MBH #2 INNER WINDING

**From:** Fred Nobrega <nobrega@fnal.gov>  
**Sent:** Friday, September 23, 2011 4:27 AM  
**To:** Gilbert M Whitson  
**Cc:** Steve Gould  
**Subject:** Re: end turn measurements

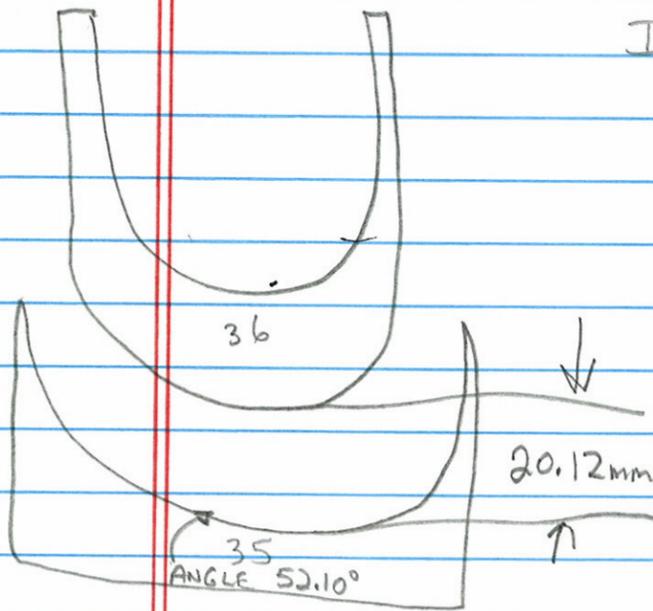
In addition to measuring the LE/RE angle, please measure the length of the 8 turns. This would be the distance from the spacer the 1st is wrapped around to the last turn of the group for a total of 8 turns in the Z directions (along the axis of the winding mandrel. A little tricky I know...

> Hi Marty,  
>  
> MBH01 last turn on layer 1 was at a very steep angle and we (CERN) are  
> looking at modifying the end saddle to have a better fit. I'm not sure  
> how far along you are on winding MBH02 but I would like for you to  
> take pictures of the last turn of each block you wind (before  
> installing the next spacer). It's okay if you are on the last block,  
> then measure the angle of the last turn and take photos (both ends).  
> This info will be used for a design iteration of the saddles.  
>  
> Thanks,  
> Fred

ITEM 25 TO ITEM 24  
CURRENT BLOCK

20.99mm (.8265")

8 TURNS ON LAST  
CURRENT BLOCK (LE) IS  
15.12mm (.5955")

ITEM 36 TO ITEM 35  
CURRENT BLOCK

20.12mm (.7925")

9 TURNS OF RE LAST CURRENT  
BLOCK IS 17.04mm (.671")

LE SADDLE  $70.25^\circ$

LE- ANGLE ON LE LAST TURN  $50.30^\circ$

RE- ANGLE ON RE LAST TURN  $52.10^\circ$

RE SADDLE  $72^\circ$
